APPLICATION FOR CONDITIONAL USE PERMIT

Case No. 92-20 - CUP Date Submitted May, 26, 1992

NAME OF PROPOSED DEVELOPMENT Texas Specialty Underwriters, Inc.

Agenda Item: P&Z 92-20-CUP/SP - Hold Public Hearing and consider Approval of a Request from Paul Davis for a Conditional Use Permit for a Structure Not Meeting the 90% Brick Requirements in the Central Business District Classification on property Located at the Corner of Alamo and Rusk Street and Approval of a Site Plan

SOUTH ELEVATION (STATE HIGHWAY 66)

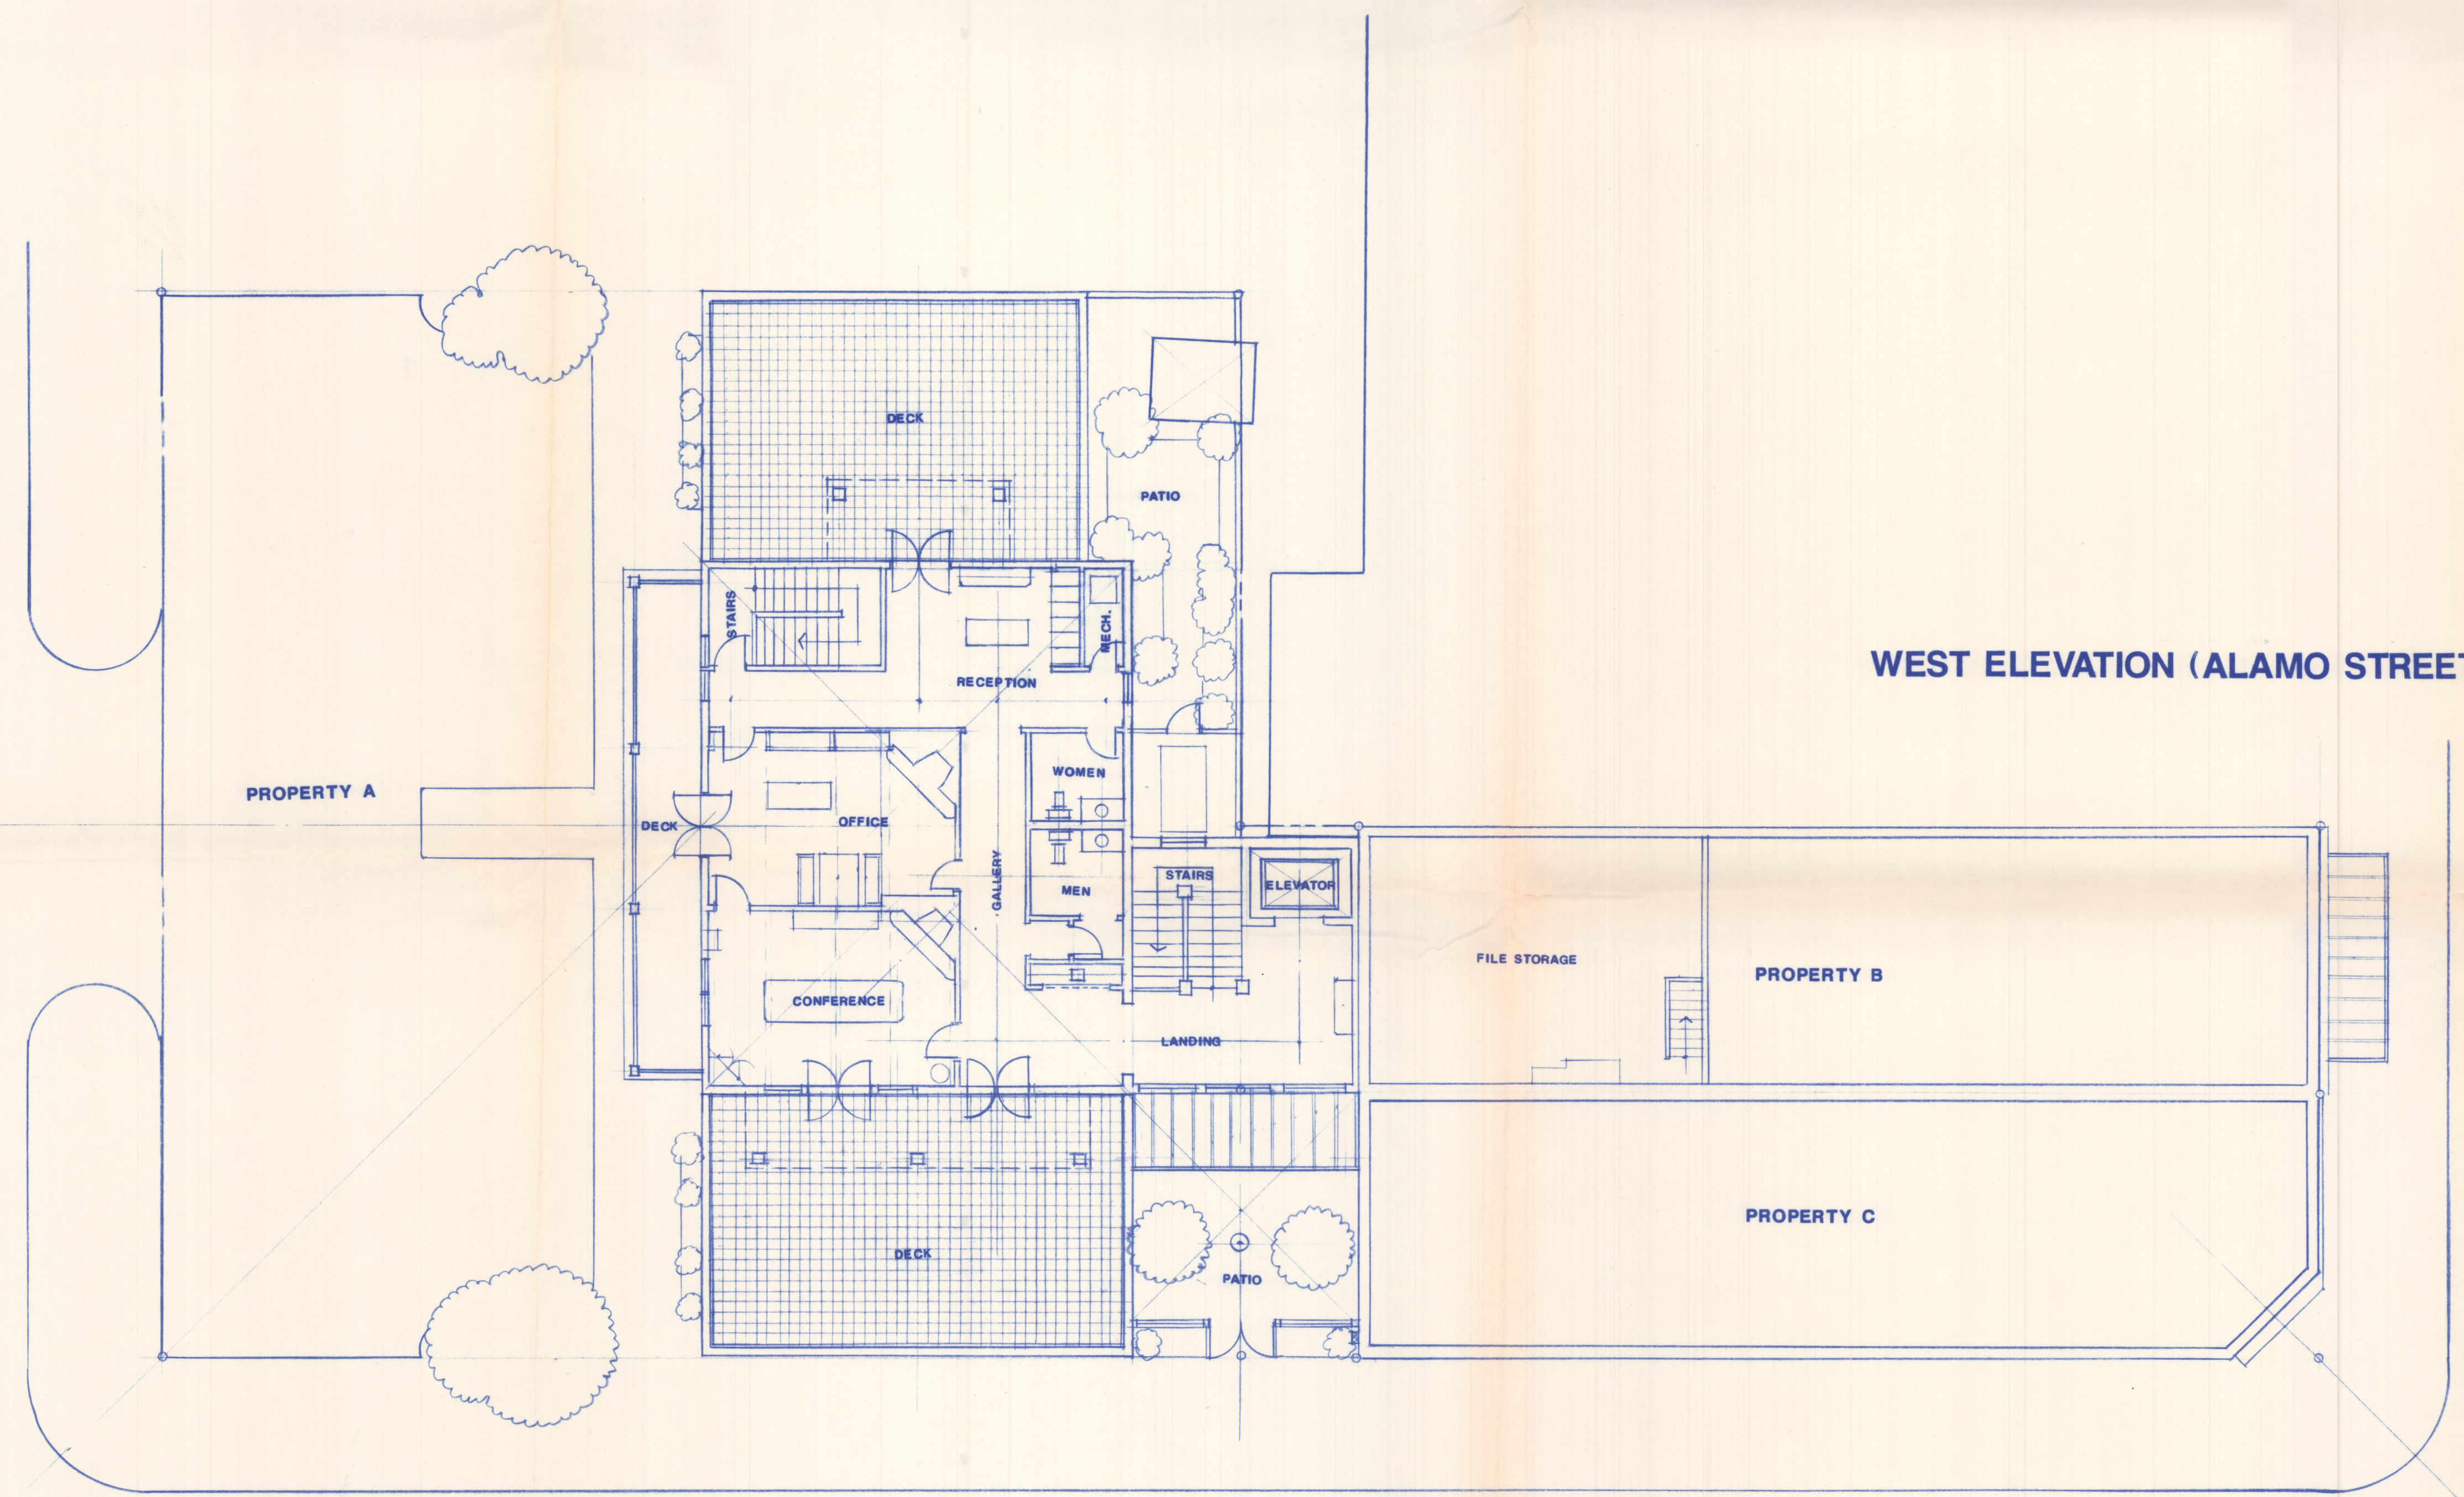
- c. Is the lot the proper size?
- d. Does the lot have proper dimensions?
- e. Are exterior materials correct? *CAD requested*
- f. Are structural materials correct? *?*

1. That the new building and the old building be painted the same color
2. That the material approved for the new building be a stucco finish utilizing a product similar to drivit.
